STAFF REPORT
COMMUNITY DEVELOPMENT DEPARTMENT

HEARING DATE: 9/6/2022
 TO: Mayor & City Council
 FROM: Joe Dodson, Associate Planner
 208-884-5533
 SUBJECT: H-2022-0036
 Lavender Place Subdivision

- Preliminary Plat consisting of four (4) single-family attached building lots and 26 single-family townhome lots on approximately 3.79 acres of land in the existing R-40 zoning district;
- Conditional Use Permit to construct 26 townhome lots within the R-40 zoning district;
- Private Street application for proposed single-family development requiring administrative approval only, by Breckon Land Design on behalf of LH Development, LLC.

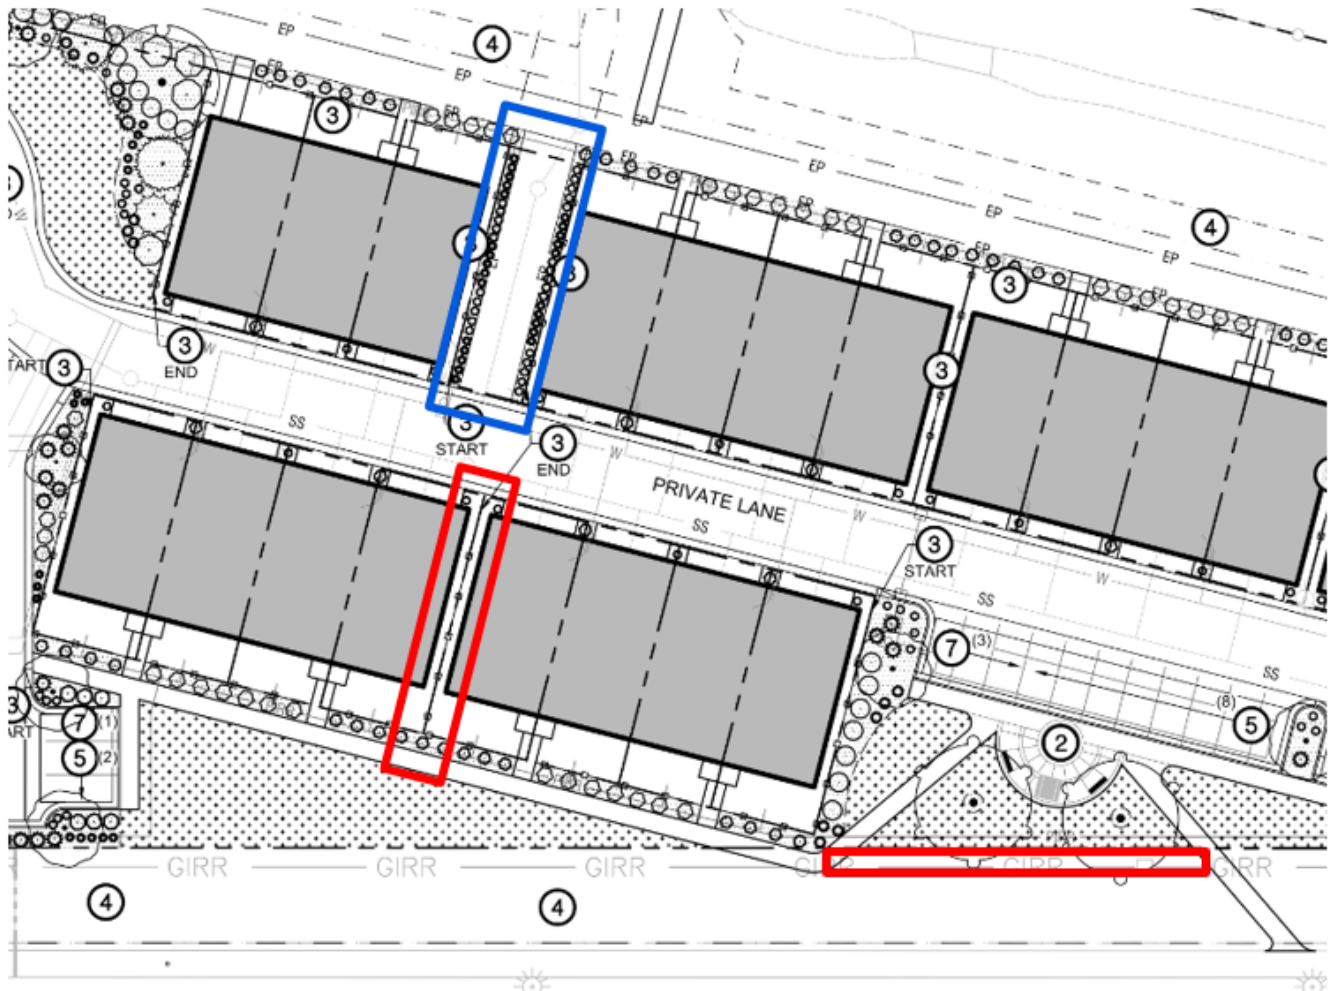
Per the submitted parking exhibit (see snip below), the Applicant is proposing to alternatively comply with the off-street parking standards by providing 18 parking spaces that will be designated for each specific unit. Each of the proposed residential units is shown with a 2-car tuck under garage providing the required off-street parking for 2-bedroom homes and meets the requirement of a 2-car garage for 3-bedroom units. However, due to the odd-shape of the parcel that creates a constrained building area, the Applicant proposed private streets and an alley-loaded product that does not readily allow for the required 20' by 20' parking pad for the nine (9) 3 and 4-bedroom homes. The Applicant placed the parking spaces directly across the private street from each unit to minimize the distance homeowners would have to traverse to access their additional parking spaces. In addition to the 18 parking spaces designated for the residents, the Applicant is also showing 7 additional guest parking spaces. NOTE: Parking is prohibited on the private street as well as along Lake Hazel and Bloomerang, the collector street where the private street takes access from.

Staff finds the proposed alternative as one option to meet the intent of the off-street parking requirements when accounting for the required density of the existing Development Agreement, site constraints, and limited access for the site. **However, upon further review, Staff is recommending a modification to the ALT request: Staff recommends one parking space is allocated for each 3 or 4-bedroom unit instead of two spaces. It is difficult to predict the number of cars each unit will produce so Staff finds it more prudent to offer additional spaces for the entire development and not just the units with more bedrooms. Staff's recommendation would increase the number of guest spaces from seven (7) up to 16 spaces which should allow for more appropriate flexibility in their use for future residents and guests of this development. An additional option, should Commission or Council find the amount of off-street parking is not adequate overall, is to limit the number of units containing 3 or 4 bedrooms as a plat condition. Staff's Alternative Compliance findings for this request are below in Section IX at the end of this report.**

- d. Revise the Alternative Compliance Parking Exhibit (Exhibit VII.D) to depict one (1) open parking space per 3 or 4-bedroom unit instead of two (2) consistent with Staff's analysis in Section V.H.

B. Preliminary Plat (dated: 3/30/2022 8/19/2022)

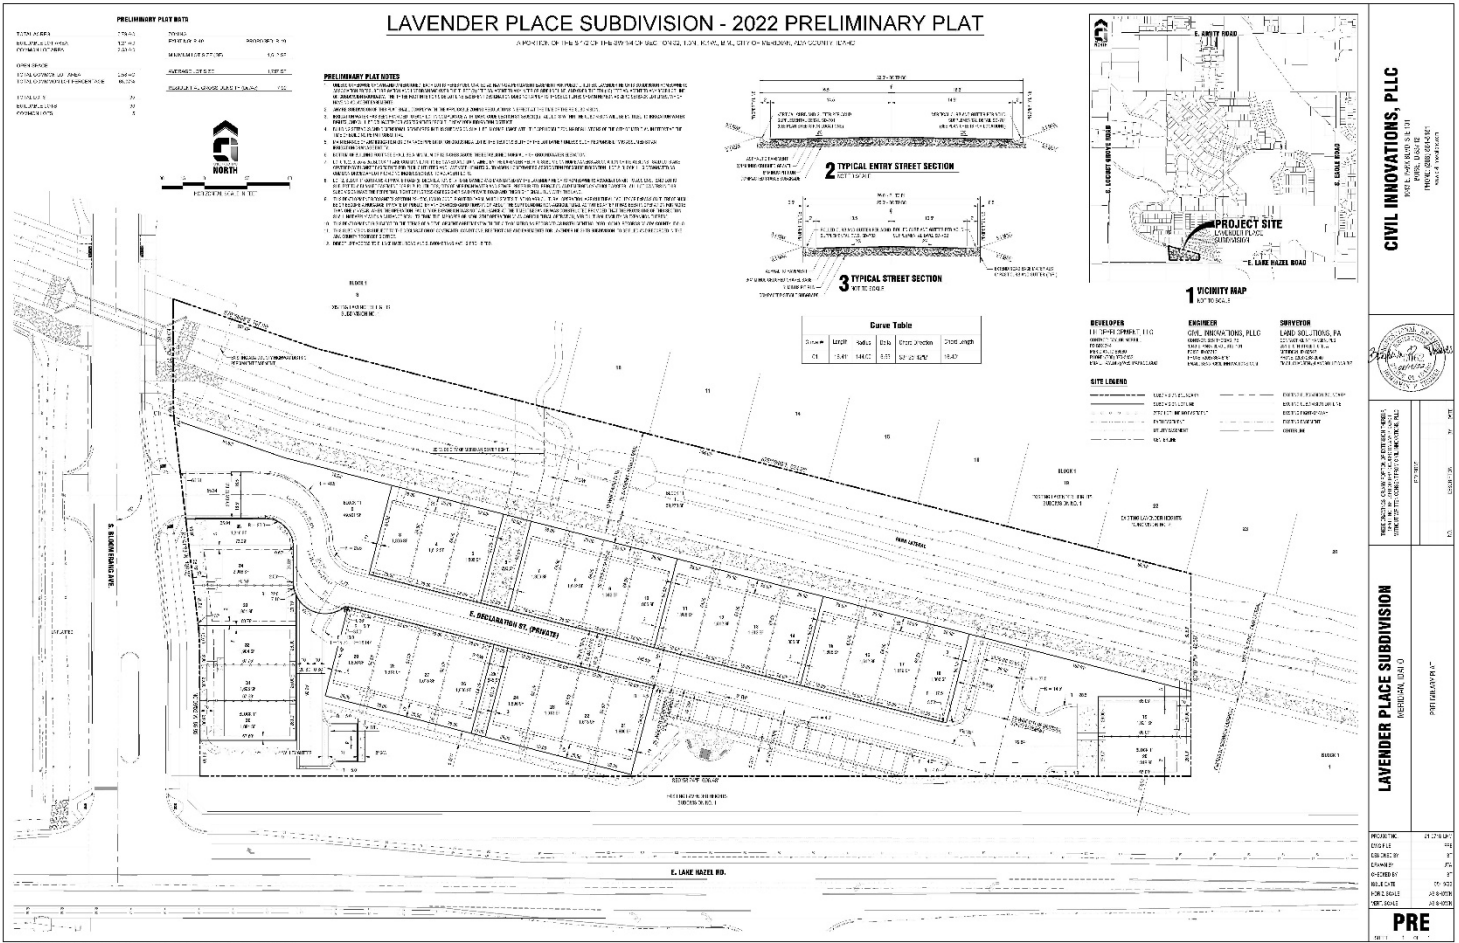
1. The preliminary plat included in Section VII.B, dated March 30, 2022, shall be revised as follows prior to the City Council hearing:
 - a. Revise the plat to add a new common, micro-path lot between Lots 24 & 25, Block 11 and an additional sidewalk connection near the plaza area for added pedestrian connectivity through the project to the existing arterial sidewalk along E. Lake Hazel Road, per the analysis in Section V.I.

- b. Add an additional common lot solely for the proposed private street per UDC 11-3F-4A and revise plat note #8 to reflect the new common lot.
 - c. Revise the placement and design of the driveways for Lots 32 and 33, Block 11 showing that the distance between the face of garage and the private street is 20' or 5' to help mitigate any conflicts of off-street parking and the proposed intersection of the common drive and private street, per the analysis in Section V.G. Parking in front of a garage less than 20 feet deep is prohibited.

- e. Revise the plat to remove the parking shown within the hammerhead turnaround at the terminus of the private street.
2. The landscape plan included in Section VII.C, dated March 30, 2022, shall be revised as follows prior to the City Council hearing:

C. Landscape Plans (date: 3/30/2022 8/22/2022)

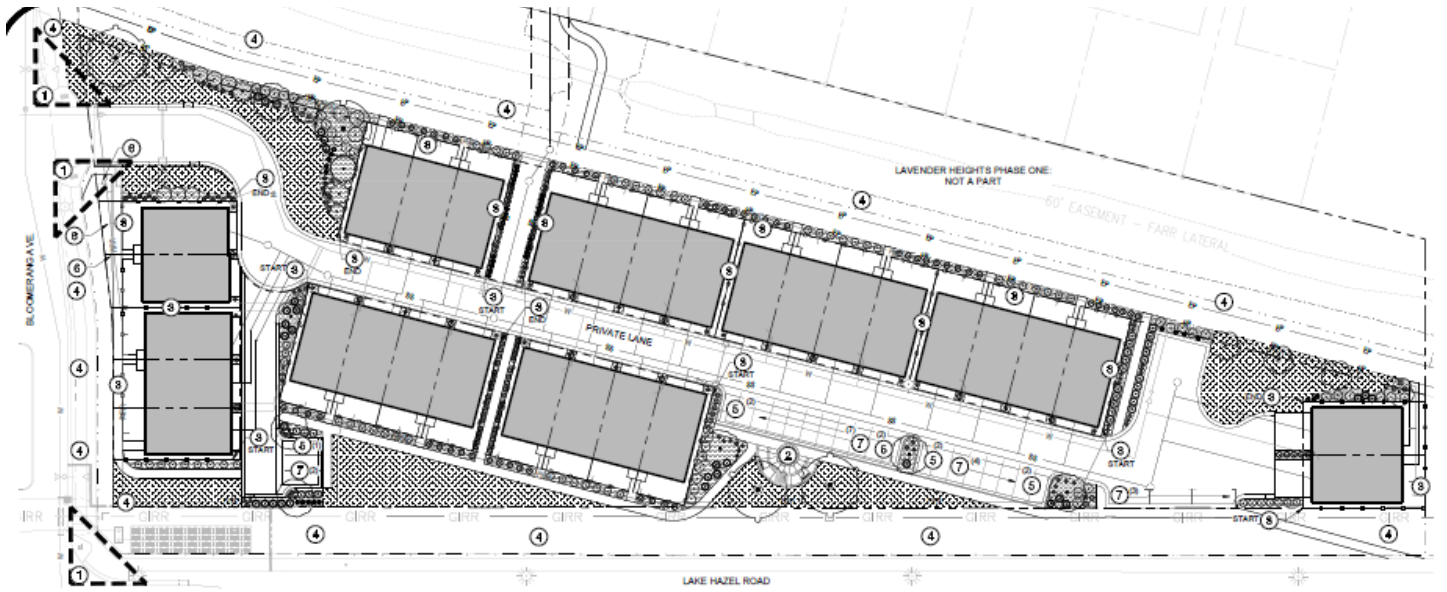
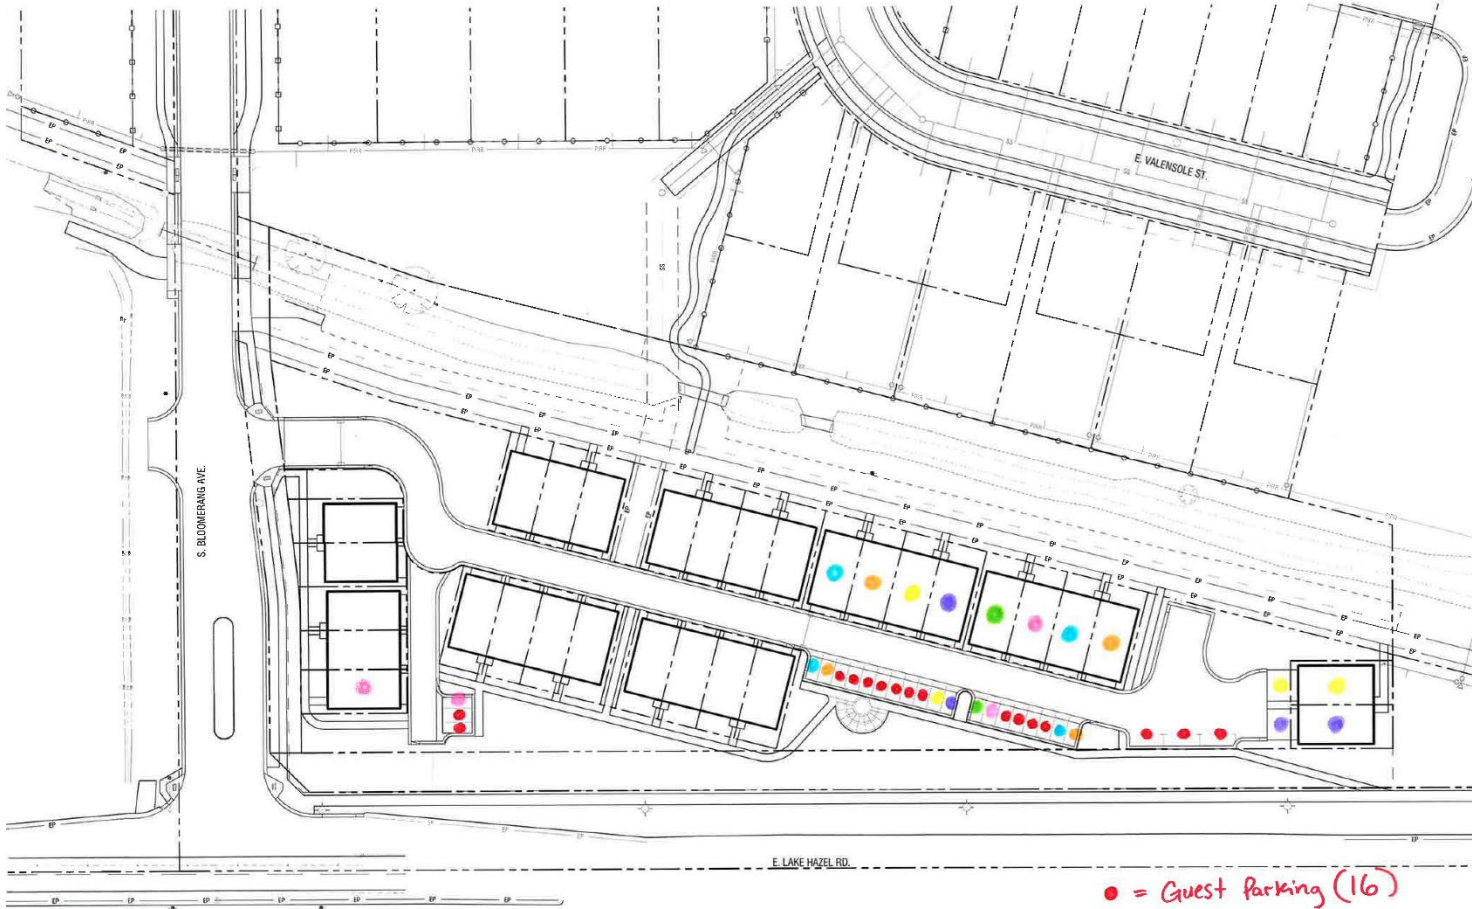
- a. Revise the landscape plan to match the plat revisions noted in VIII.A1 above.
 - b. Add shrubs and other vegetative ground cover adjacent to the recommended new micro-path between Lots 24 & 25, Block 11.
